TOWN OF DEWEY-HUMBOLDT
P.O. BOX 69
HUMBOLDT, AZ 86329
Phone 928-632-7362 ▪ Fax 928-632-7365

May 13, 2023

Re: Town of Dewey-Humboldt's Comments on the U.S. Environmental Protection Agency's Proposed Remedial Action Plan, dated March 1, 2023, for the Iron King Mine-Humboldt Smelter Superfund Site, Dewey-Humboldt, Arizona

BACKGROUND ARSENIC (AS) DATA FOR IKMHS SUPERFUND SITE BTV | TOTAL

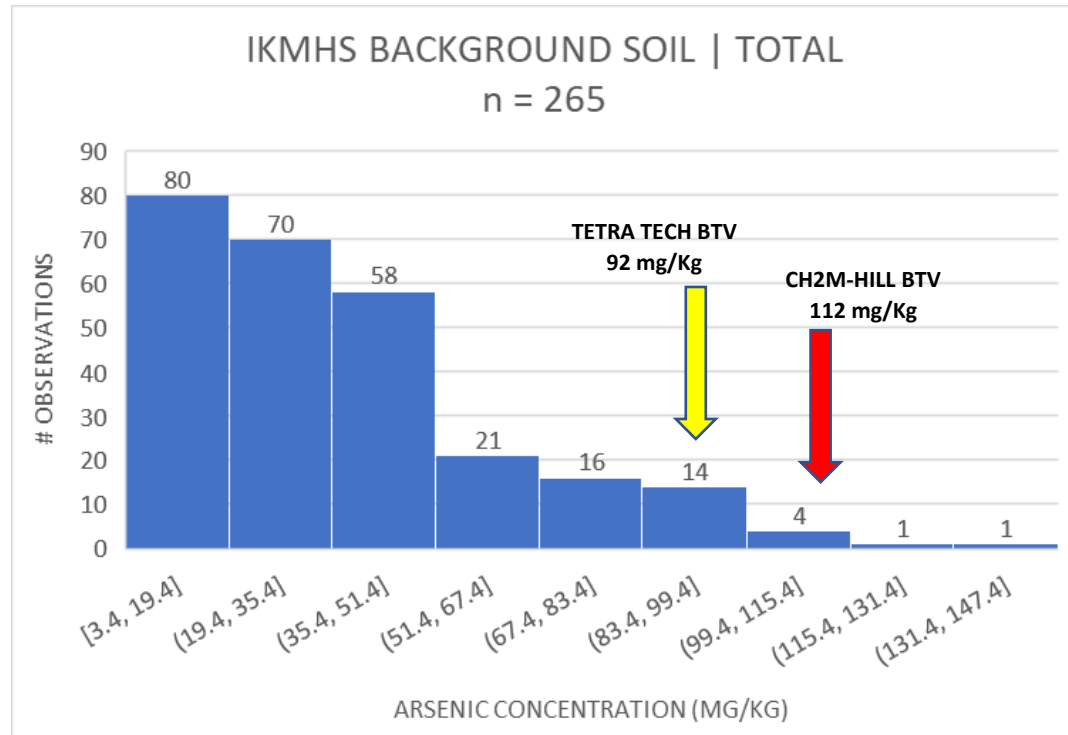
CH2M-Hill (2016; Appendix E) and Tetra Tech (2022; Appendix C-6) applied the same dataset consisting of 269 data from soil sample locations outside the perimeter of the IKMHS Superfund Site to calculate a Background Threshold Value (BTV) for Arsenic (As). CH2M-Hill calculated a BTV of 112 mg/Kg Arsenic. Tetra Tech calculated a BTV for Arsenic equal to 92 mg/Kg.

Two (2) values to the far right of the Histogram are outliers identified by calculations provided by USEPA Guidance Documents (USEPA, 2002c). Likewise, two (2) values of the four (4) identified in Bin 7 should be removed based on standard industry practice.

BACKGROUND ARSENIC (AS) DATA FOR IKMHS SUPERFUND SITE BTV | BALON SOIL

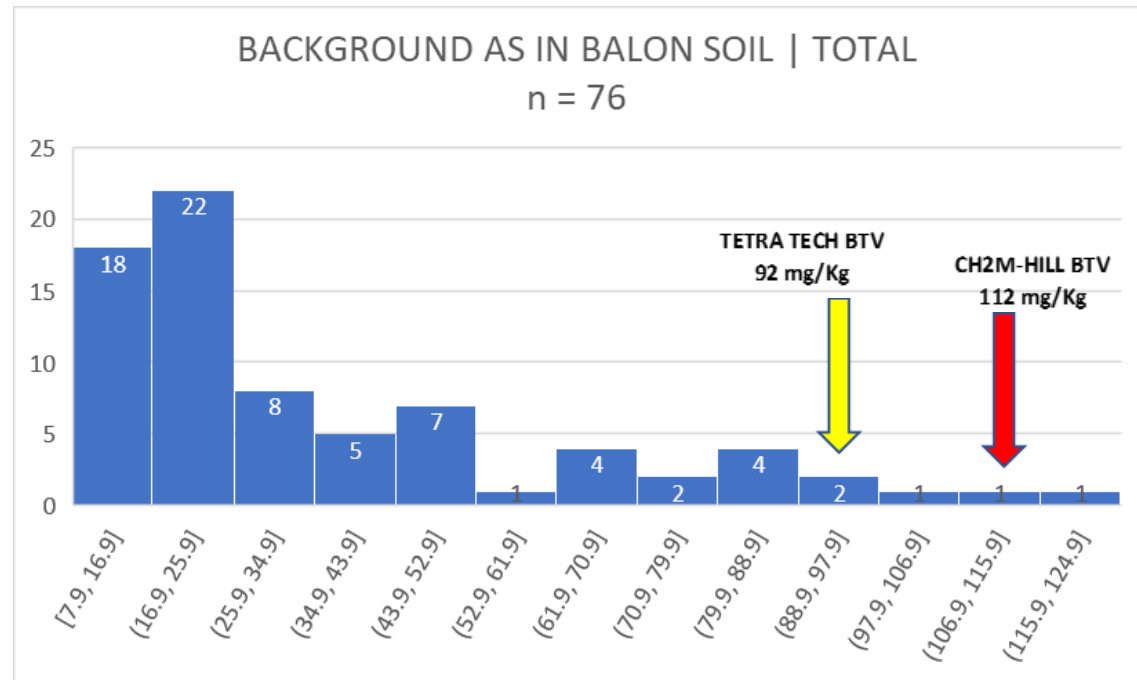
Balon Soil occupies a dominant area of the Superfund Site and is located in areas considered to be the most sensitive with regard to location of potential receptors, including Town properties and residential neighborhoods located northeast and east of the Iron King Mine proper and north and northwest from the Humboldt Smelter property. Balon Soil represents an important site-specific source of information regarding background arsenic concentrations. Two (2) of the outliers that were not removed from the operative dataset are present on this graph and significantly affect the dataset mean and standard deviation values.

BACKGROUND ARSENIC (AS) DATA FOR IKMHS SUPERFUND SITE BTV | BALON

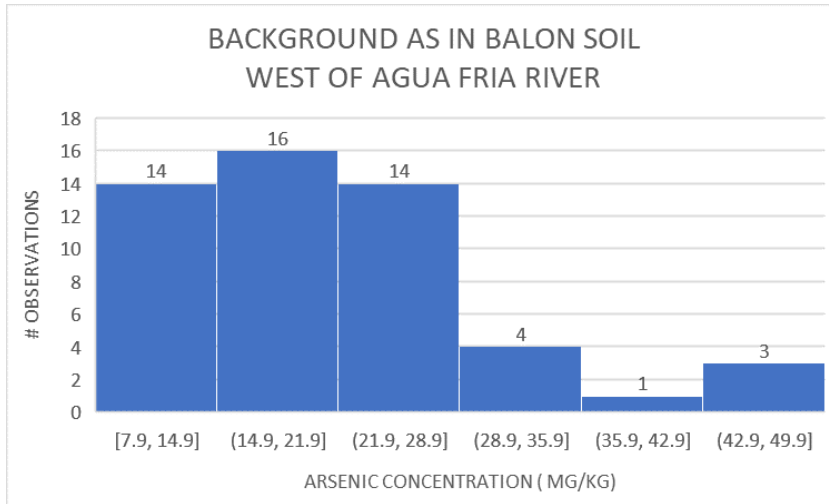
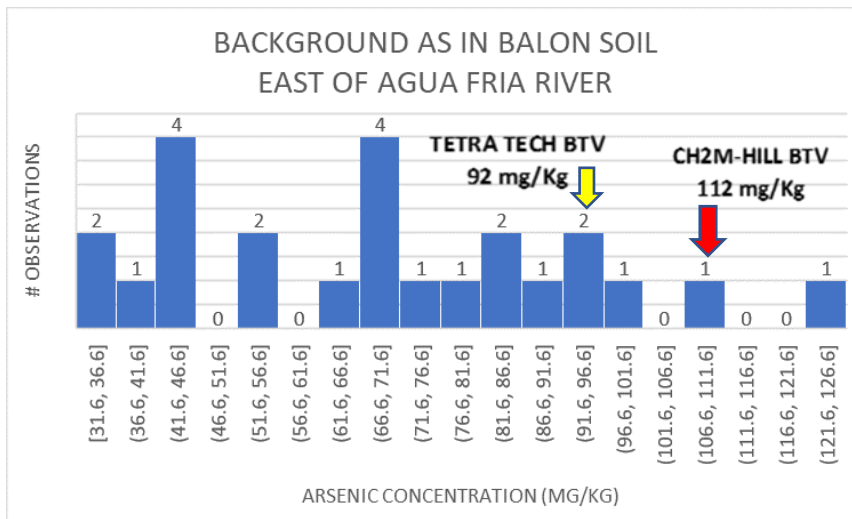
Balon Soil Arsenic data from samples collected East of the Agua Fria River significantly differ from sample data for samples collected West of the River. Data distribution attributes, maximum values, and standard deviation are significantly different. All data that exceed 59 mg/Kg in Balon Soil from all locations around the IKMHS Superfund Site are present in this data subset, comprising over 60% of the Balon-East dataset count. The CH2M-Hill and Tetra Tech BTVs are not even represented in the Balon-West dataset wherein the highest Arsenic concentration value is about 50% of the 92 mg/Kg BTV assigned by Tetra Tech.

BACKGROUND ARSENIC (AS) DATA FOR IKMHS SUPERFUND SITE BTV | MOANO SOIL

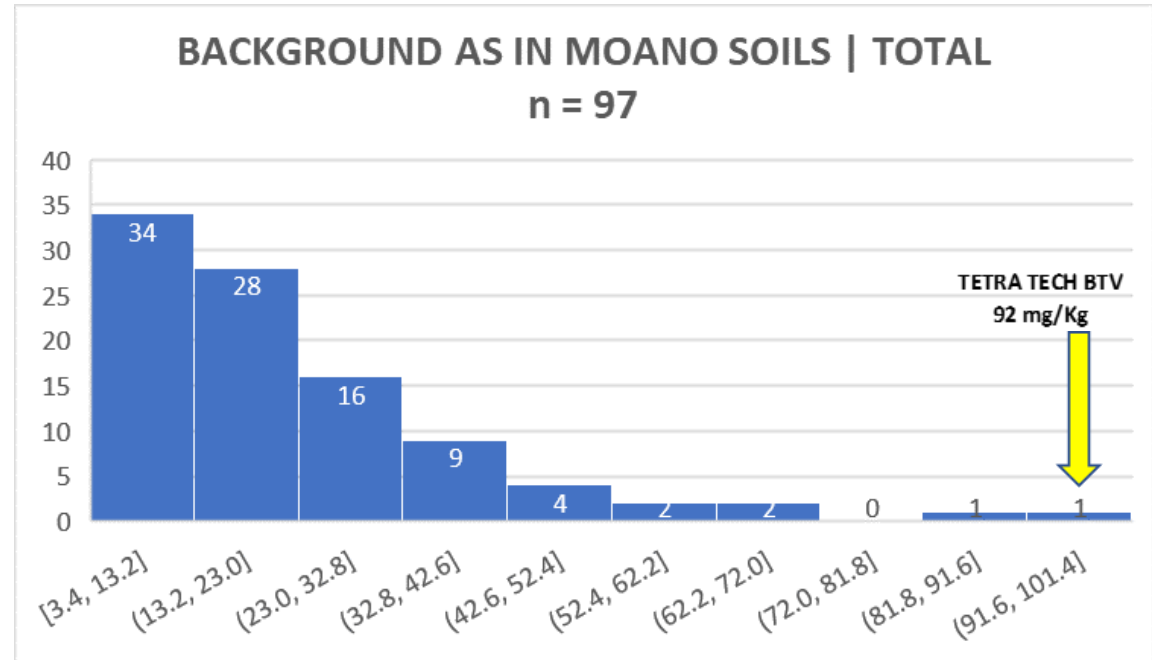
Moano Soils include three types of which two (2) are located within the boundary of the IKMHS Superfund Site (see Figures 3 & 4, Tetra Tech Appendix C-6 (2022)). Moano Soils compose the bulk of Area of Concern 12, located south-southwest of the Iron King Mine proper, south of Galena Gulch. In addition, Moano Soils are present along the east margin of Agua Fria River east, southeast, and south of the Humboldt Smelter property.

BACKGROUND ARSENIC (AS) DATA | LONTI SOIL (TOTAL)

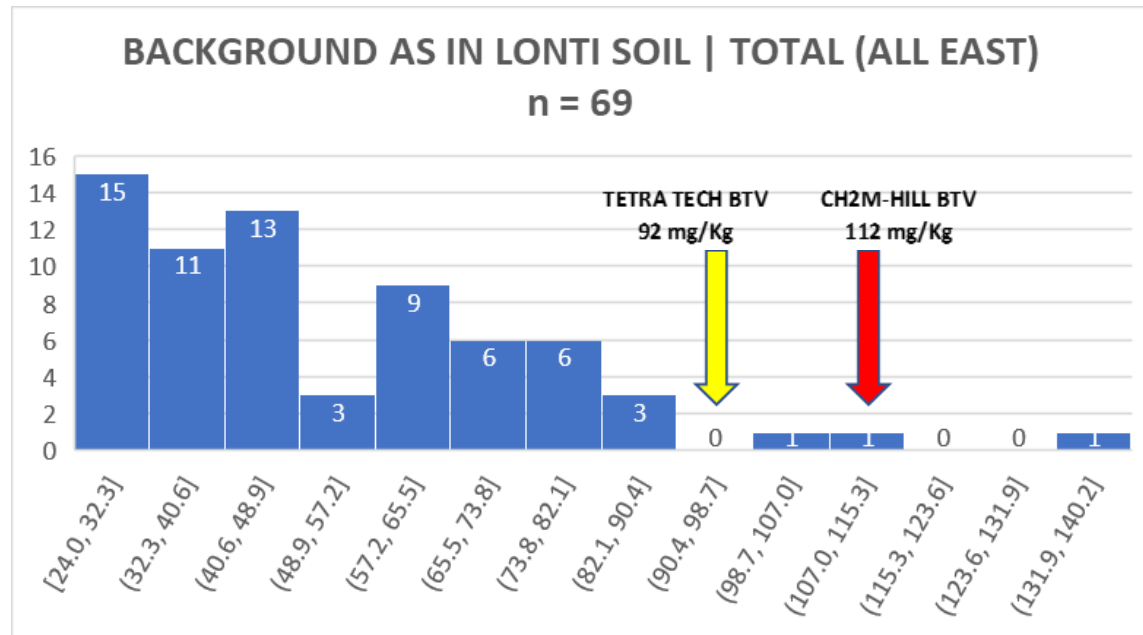
According to Figures 3 and 4, as presented in Appendix C-6 of the Tetra Tech Feasibility Study (FS), Lonti Soil does not occur within the boundaries of the Iron King Mine/Humboldt Smelter Superfund Site. Lonti Soil only occurs on the East side of the Agua Fria River and north-northeast of the Superfund Site boundary. These data, though not applicable to the Superfund Site, indicate that the assignment of a BTV that represents the average background concentration of Arsenic in Site soils is significantly less than the BTVs calculated by Tetra tech.

BACKGROUND ARSENIC (AS) DATA FOR IKMHS SUPERFUND SITE BTV | TOTAL

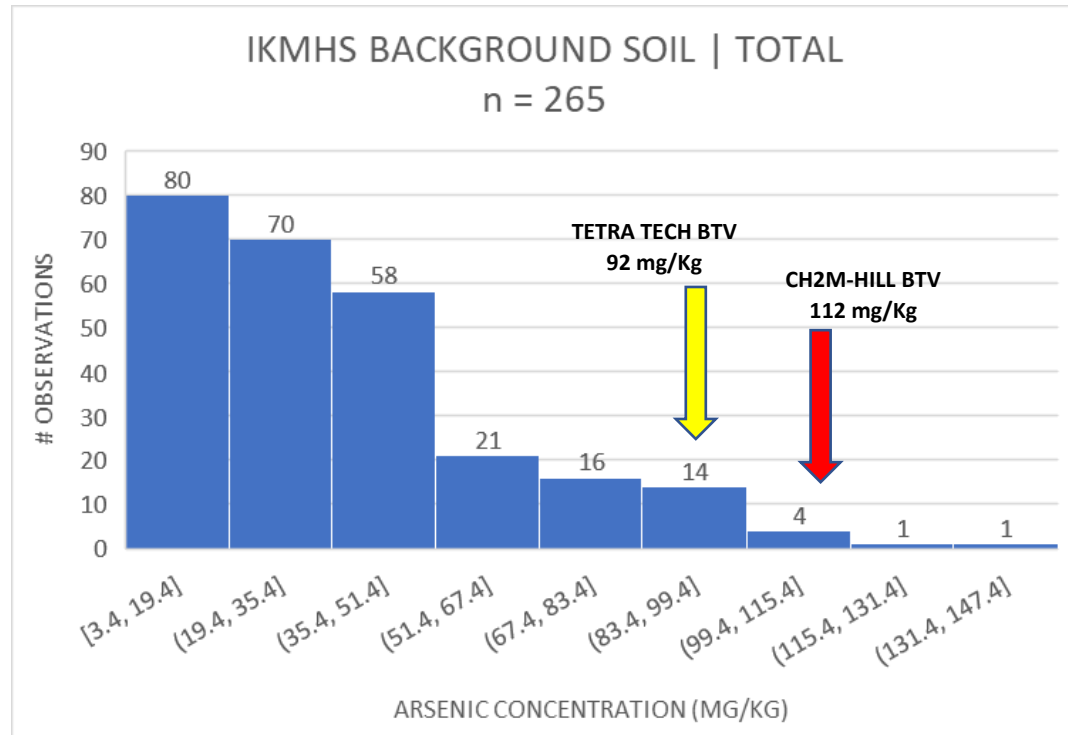
CH2M-Hill (2016; Appendix E) and Tetra Tech (2022; Appendix C-6) applied the same dataset consisting of 269 data from soil sample locations outside the perimeter of the IKMHS Superfund Site to calculate a Background Threshold Value (BTV) for Arsenic (As). CH2M-Hill calculated a BTV of 112 mg/Kg Arsenic. Tetra Tech calculated a BTV for Arsenic equal to 92 mg/Kg.

Two (2) values to the far right of the Histogram are outliers identified by calculations provided by USEPA Guidance Documents (USEPA, 2002c). Likewise, two (2) values of the four (4) identified in Bin 7 should be removed based on standard industry practice.

BACKGROUND ARSENIC (AS) DATA FOR IKMHS SUPERFUND SITE BTV | BALON SOIL

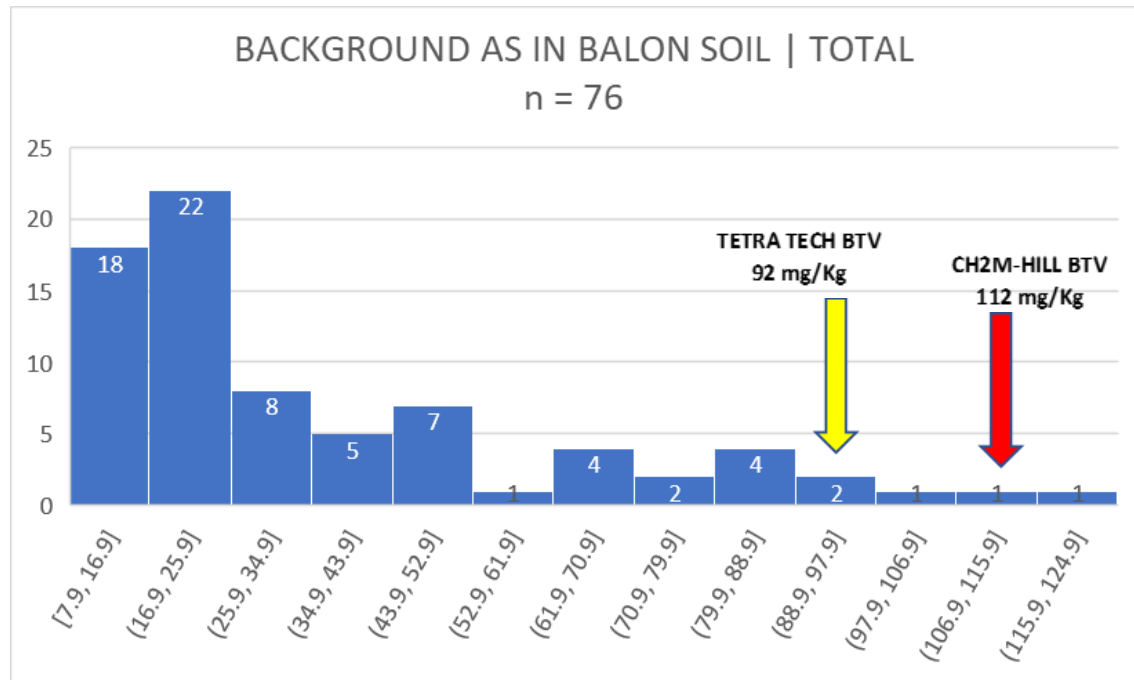
Balon Soil occupies a dominant area of the Superfund Site and is located in areas considered to be the most sensitive with regard to location of potential receptors, including Town properties and residential neighborhoods located northeast and east of the Iron King Mine proper and north and northwest from the Humboldt Smelter property. Balon Soil represents an important site-specific source of information regarding background arsenic concentrations. Two (2) of the outliers that were not removed from the operative dataset are present on this graph and significantly affect the dataset mean and standard deviation values.

BACKGROUND ARSENIC (AS) DATA FOR IKMHS SUPERFUND SITE BTV | BALON

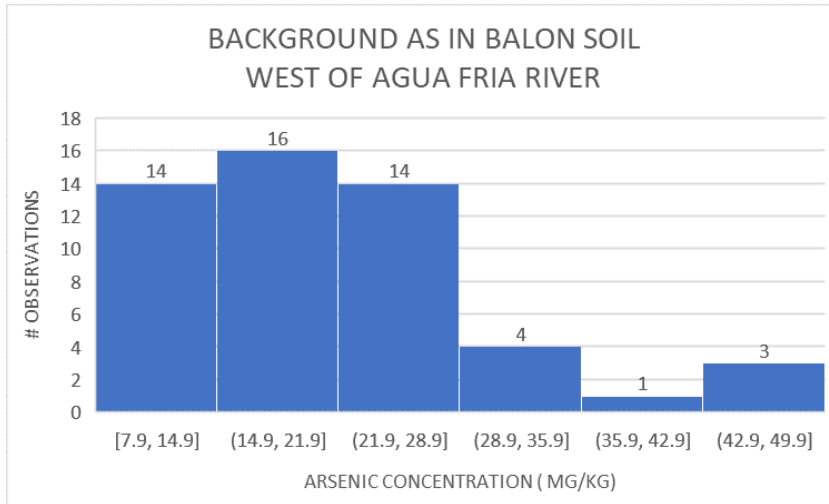
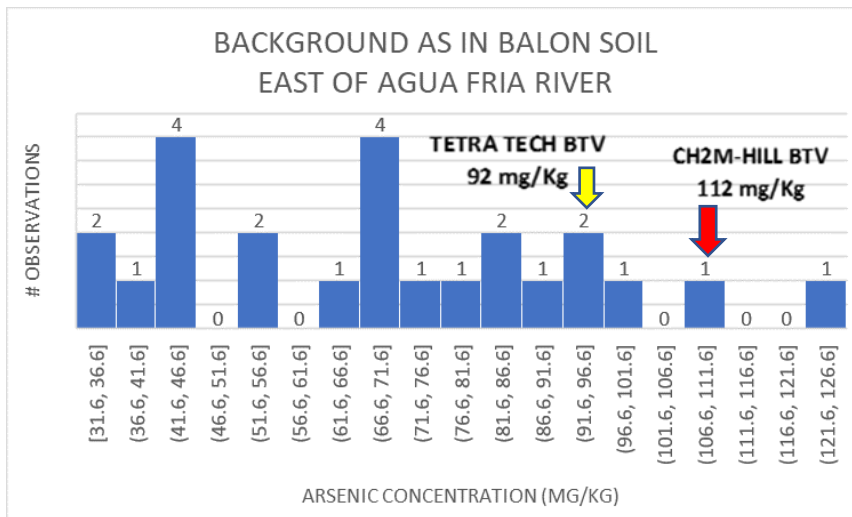
Balon Soil Arsenic data from samples collected East of the Agua Fria River significantly differ from sample data for samples collected West of the River. Data distribution attributes, maximum values, and standard deviation are significantly different. All data that exceed 59 mg/Kg in Balon Soil from all locations around the IKMHS Superfund Site are present in this data subset, comprising over 60% of the Balon-East dataset count. The CH2M-Hill and Tetra Tech BTVs are not even represented in the Balon-West dataset wherein the highest Arsenic concentration value is about 50% of the 92 mg/Kg BTV assigned by Tetra Tech.

BACKGROUND ARSENIC (AS) DATA FOR IKMHS SUPERFUND SITE BTV | MOANO SOIL

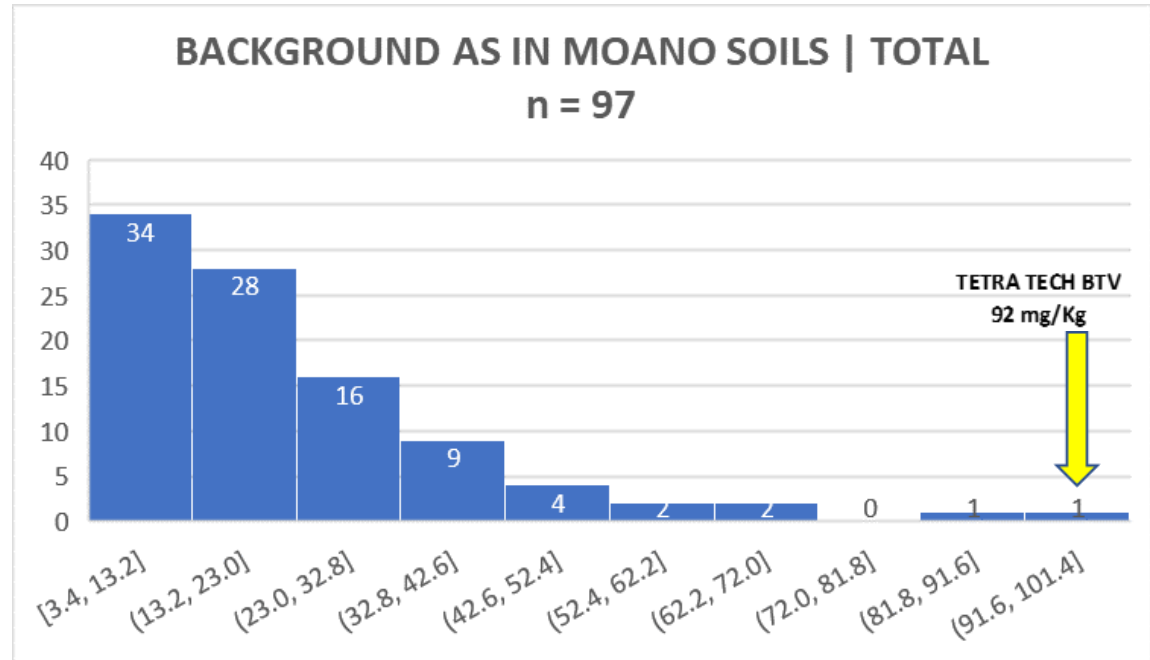
Moano Soils include three types of which two (2) are located within the boundary of the IKMHS Superfund Site (see Figures 3 & 4, Tetra Tech Appendix C-6 (2022)). Moano Soils compose the bulk of Area of Concern 12, located south-southwest of the Iron King Mine proper, south of Galena Gulch. In addition, Moano Soils are present along the east margin of Agua Fria River east, southeast, and south of the Humboldt Smelter property.

BACKGROUND ARSENIC (AS) DATA | LONTI SOIL (TOTAL)

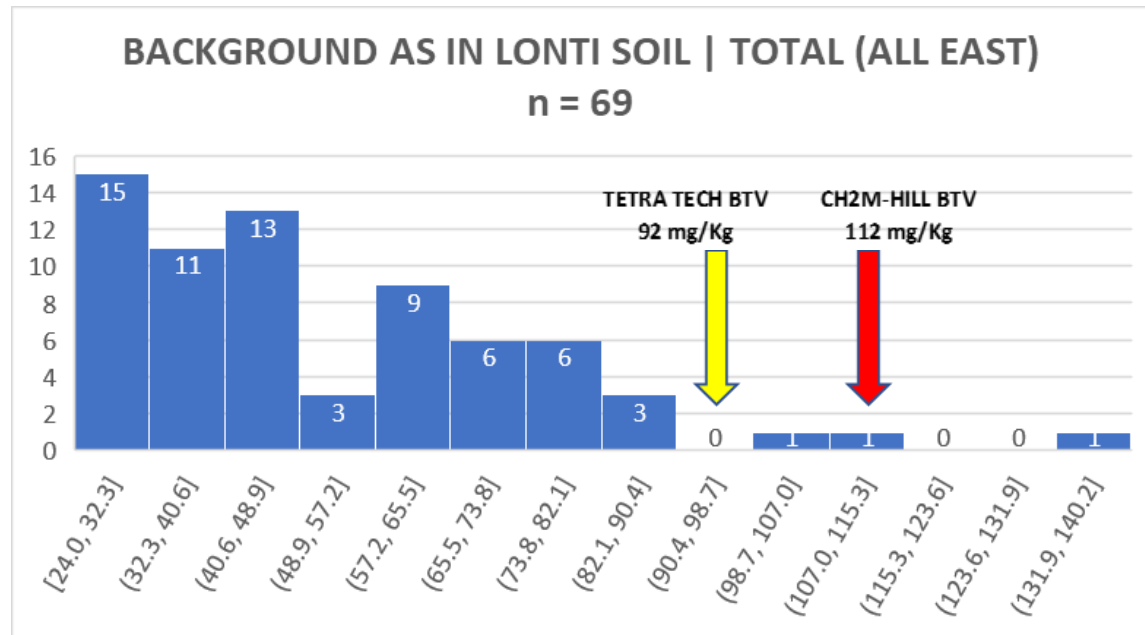
According to Figures 3 and 4, as presented in Appendix C-6 of the Tetra Tech Feasibility Study (FS), Lonti Soil does not occur within the boundaries of the Iron King Mine/Humboldt Smelter Superfund Site. Lonti Soil only occurs on the East side of the Agua Fria River and north-northeast of the Superfund Site boundary. These data, though not applicable to the Superfund Site, indicate that the assignment of a BTV that represents the average background concentration of Arsenic in Site soils is significantly less than the BTVs calculated by Tetra tech.
